**AMENDMENTS TO THE DRAWINGS**

**REMARKS**

Application No. 10/735,488

**ANNOTATED SHEET SHOWING CHANGES TO FIGURE 7**

FIG. 7  
(PRIOR ART)

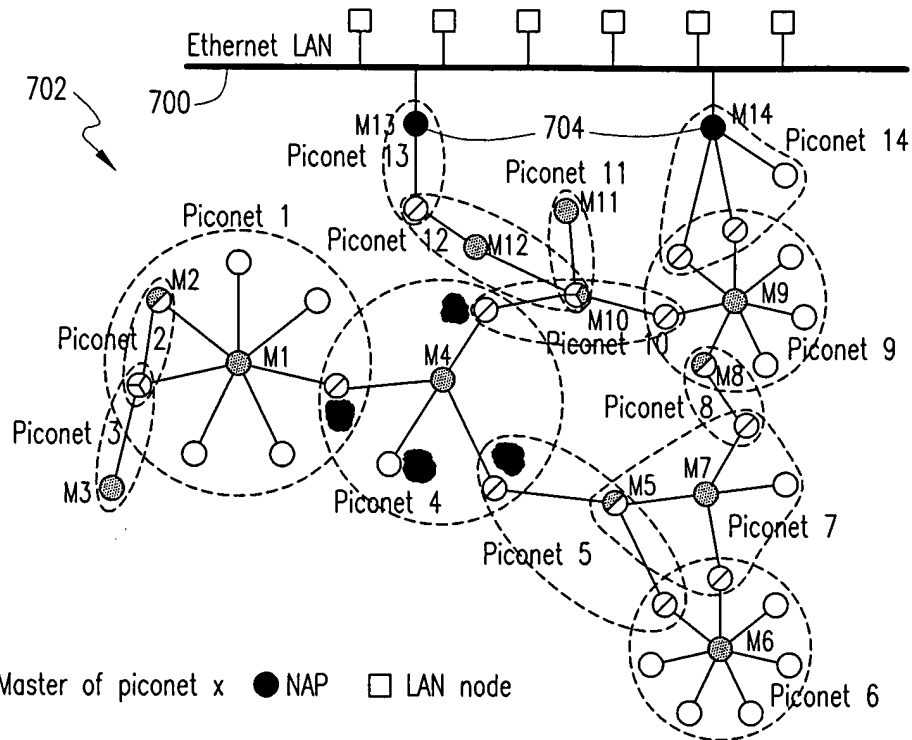
Figure 7 of the drawings is hereby amended to add the reference labels "S1," "S2," "S3," and "S4" to the four nodes directly connected to node "M4." Support for the amendment may be found in the specification in the paragraph bridging pages 31 and 32.
